MOTION / PRESENCE DETECTION SYSTEM

Patent #4,736,097

UPDATES

EYE CUE RETROFIT Wiring Revisions

INSTALLATION WIRING DIAGRAM

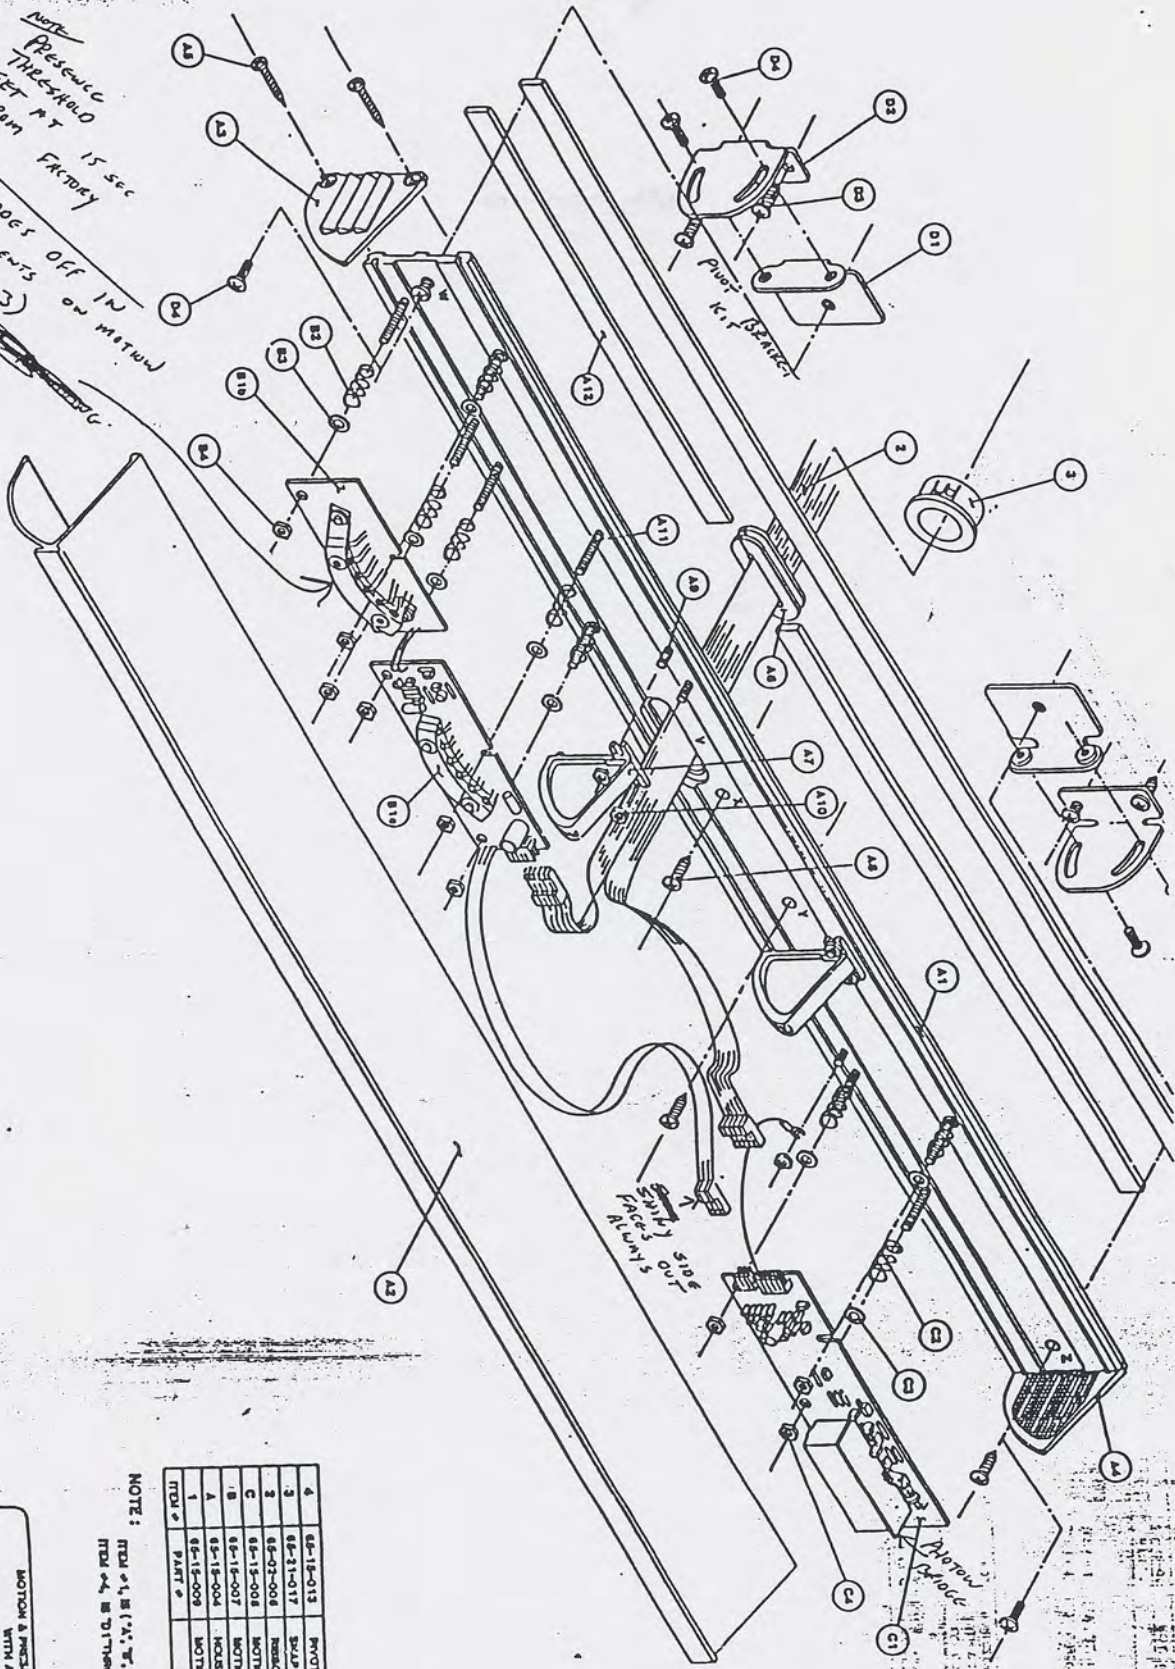
Listed below are the revised wiring procedures for retrofitting the Eye Cue System to the earlier "A" Series (w/mechanical limit switches/or "B" Series (w/red magnetic limit switches) sliding door packages.

1. "A" or "B" Series without 4 position switch or electric carriage locks. Wiring: Normal wiring as shown on installation wiring Diagram D26037 in the manual (no special relay module required).
2. "A" Series with electric carriage lock or 4 position switch. Wiring: See enclosed installation wiring Diagram D26037 Revision A. (Special 5 relay module #65-02-012 required.)
3. "B" Series with electric carriage lock or 4 position switch. Wiring: See enclosed installation wiring Diagram D26037 Revision A. (Special 4 relay module #65-02-020 required.)

Please make the necessary revisions to all installation wiring diagrams.

TITLE. EYE-CUE PREP & ASSY DWG.
4000 SERIES-'C' SWITCH-NON PANIC

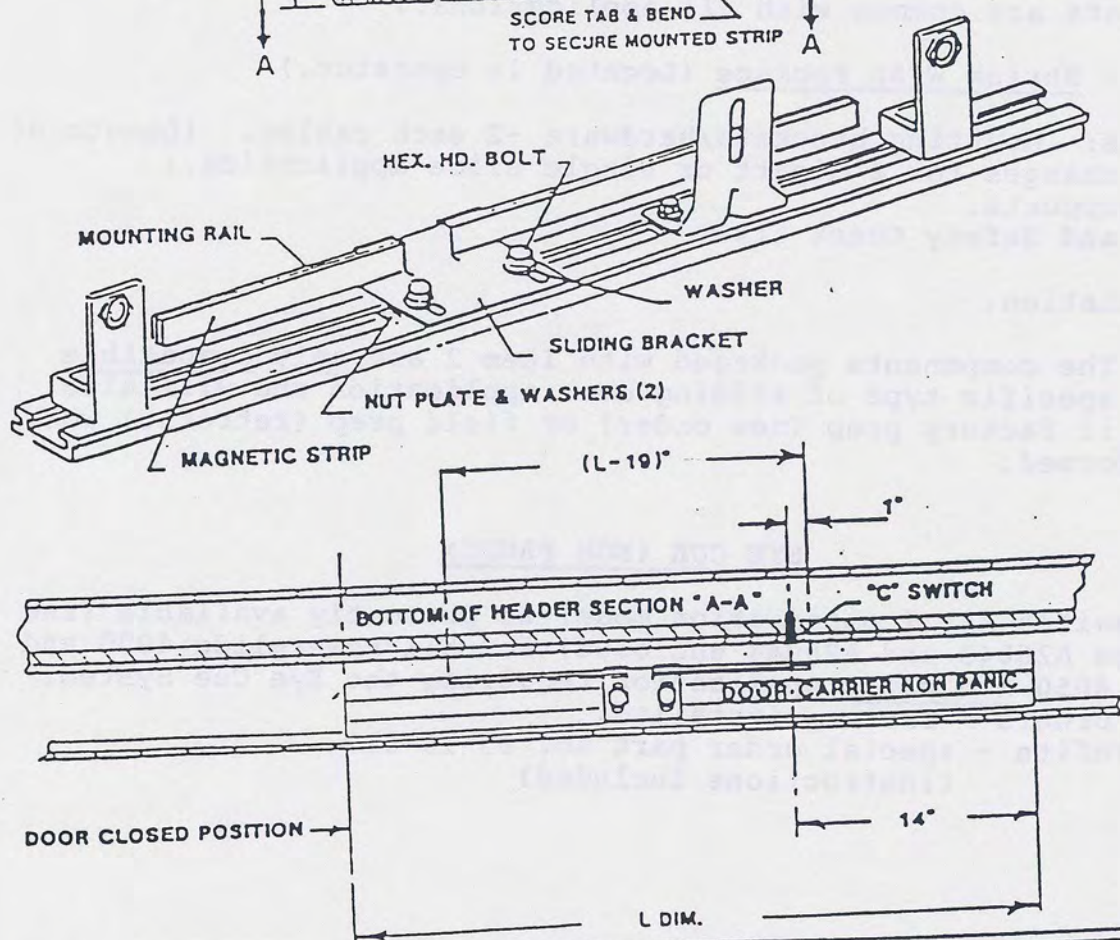
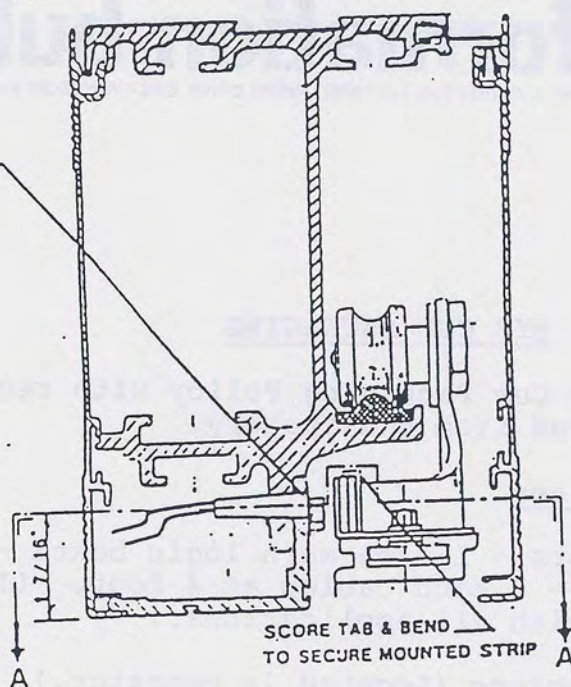
A "C" switch kit (compensation mode) is presently available (see drawings A26043 and A26044 enclosed) for all Powerglide 4000 and EZ Fit 4050 non panic application requiring the Eye Cue System.

DRILL 3/8" DIA.
& C/SINK 1/2" DIA.
INSTALL "C" SWITCH
WITH ADHESIVE

PRE NOV. 89

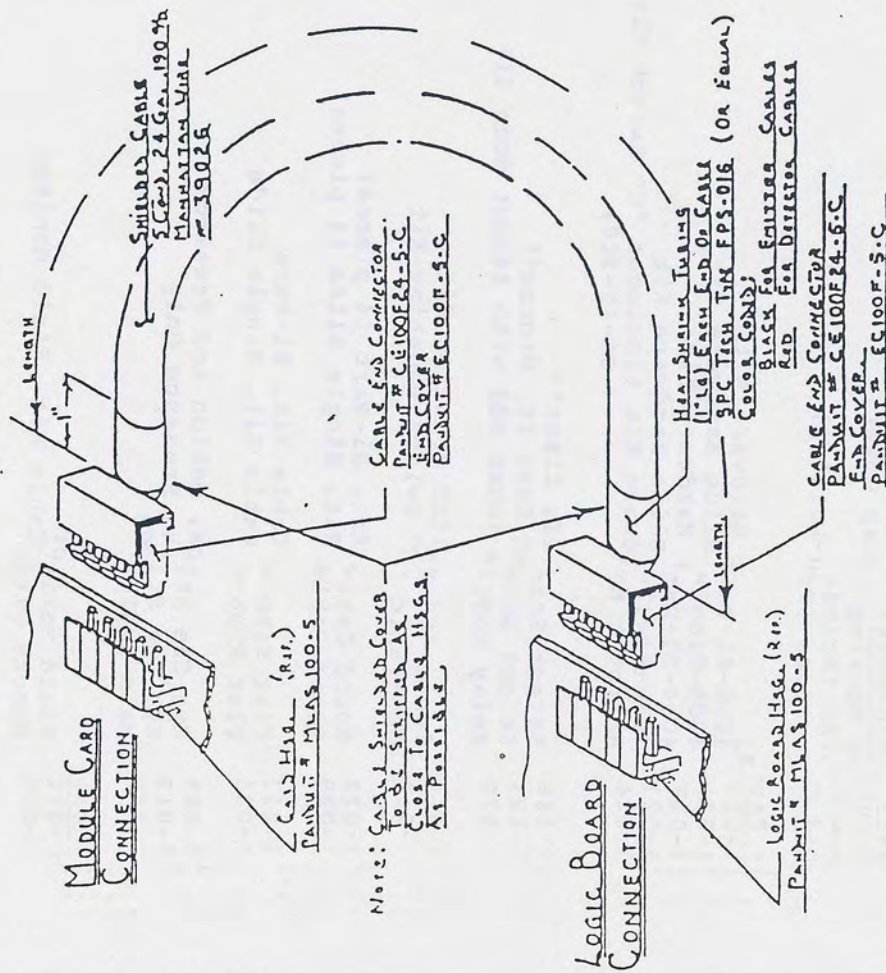
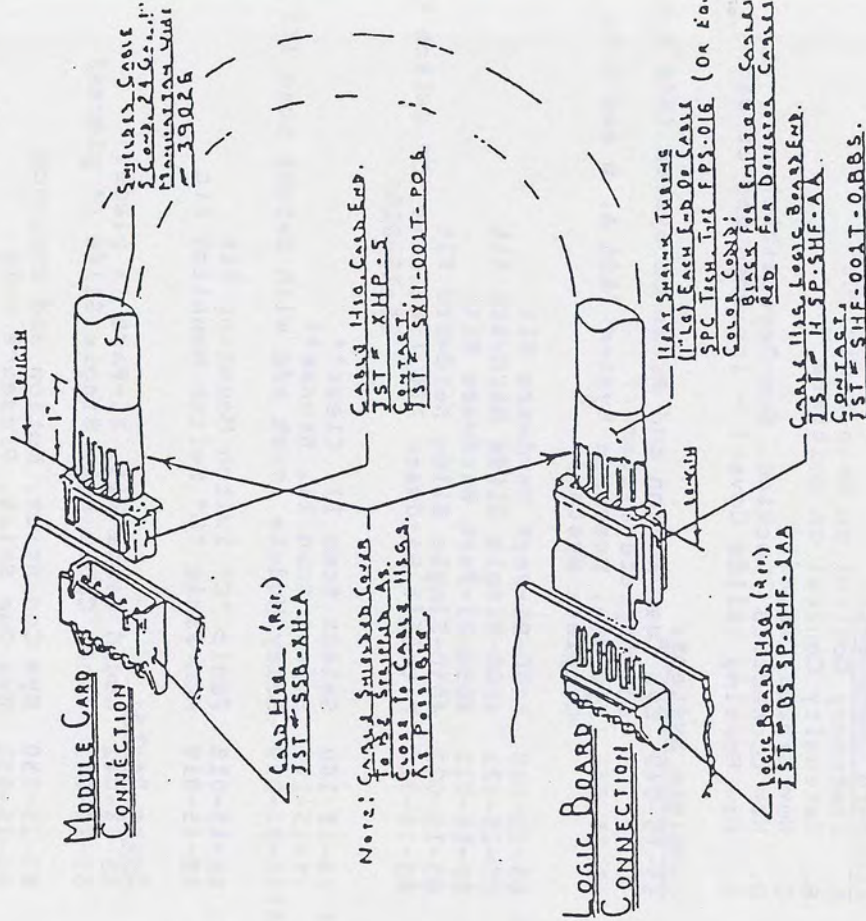
We are pleased to announce that all Eye Cue product enhancements, which were previously outlined in Bulletin 173, have been completed and are included in all shipments effective November 1, 1989. Delivery of the new sensor housing will be delayed until the end of December. It's important to note that some of the new improvements have created a situation where certain components of the earlier systems pre-November, 1989 (Ser. #1599 and below) and the present system post November 1, 1989 (Ser. #1600 and above) are not compatible with each other. An example of this (see enclosed dwg.) is the new non-reversible, locking cable system employed in the latest system.

In order to eliminate any confusion regarding the two systems, we are enclosing complete part's list for both. All components with the same part numbers are interchangeable. The requested field monitoring extension kit is presently available as an optional accessory. The Kit (see enclosed dwg.) must be field installed and is compatible with all systems.

II. Post-November '89 Eye Cue: (Serial Number 1600 and After)

A. Frequency Control on Main Logic PCB
B. Intensity Control on Emitters
C. New Cables (Round)
D. New Connectors (Locking, Non-Reversible)
E. New Housing (Slide Cover) - included end of Dec.
